Access Compliance Report

Public Rights-of-Way

Intersection ID: 10038340	Main Street: SOUTH_BV	Cross Street: N/A	Location: NW
ADA ID: B86920CEE0D7	Ramp Type: Perp	Initial Pass/Fail: Fail	Overall Compliance: No
		Severity Score: 12.5

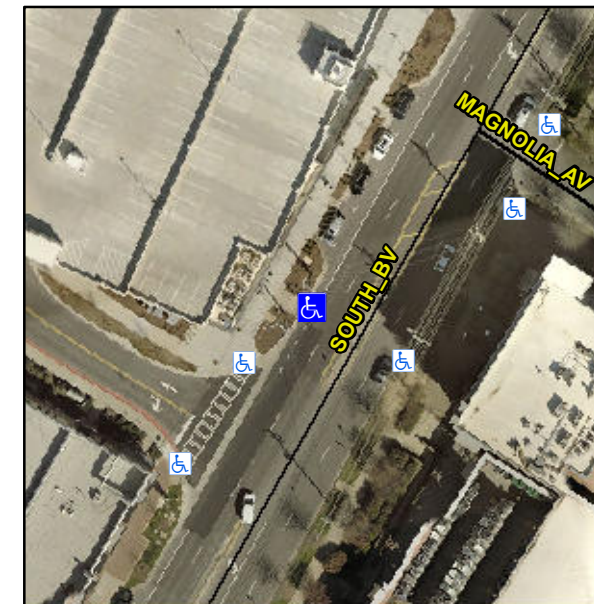
Not Found, R304.2.2

Compliance	Description	Data	Compliance	Description	Data
N/A	Ramp Length (in)	65.0	No	Ramp Slope (%)	9.6
Yes	Ramp Width (in)	59.0	Yes	Ramp XSlope (%)	0.3
N/A	Flare Type LT	N/A	N/A	Flare Type RT	N/A
N/A	Flare Slope LT (%)	N/A	N/A	Flare Slope RT (%)	N/A
N/A	Flare Traversable LT?	N/A	N/A	Flare Traversable RT?	N/A
N/A	Landing Length (in)	N/A	N/A	DWS Provided?	N/A
N/A	Landing Width (in)	N/A	N/A	DWS Contrast?	N/A
N/A	Landing Slope (%)	N/A	N/A	DWS Length (in)	N/A
N/A	Landing X Slope (%)	N/A	N/A	DWS Full Width?	N/A
N/A	Landing Curb? (Y/N)	N/A	N/A	DWS Offset (in)	N/A
N/A	Shared Landing?	N/A			
N/A	Gutter Ponding?	N/A	N/A	Gutter Slope (%)	N/A
N/A	Gutter Lip Ht (in)	N/A	N/A	Gutter X Slope (%)	N/A
N/A	Painted X Walk1?	No	N/A	Painted X Walk2?	N/A
	X Walk 1 Direction	To SE		X Walk 2 Direction	N/A
N/A	X Walk 1 Width (in)	N/A	N/A	X Walk 2 Width (in)	N/A
	X Walk 1 Slope (%)	2.2		X Walk 2 Slope (%)	N/A
	X Walk 1 X Slope (%)	1.6		X Walk 2 X Slope (%)	N/A

Remove & Replace Entire Ramp.
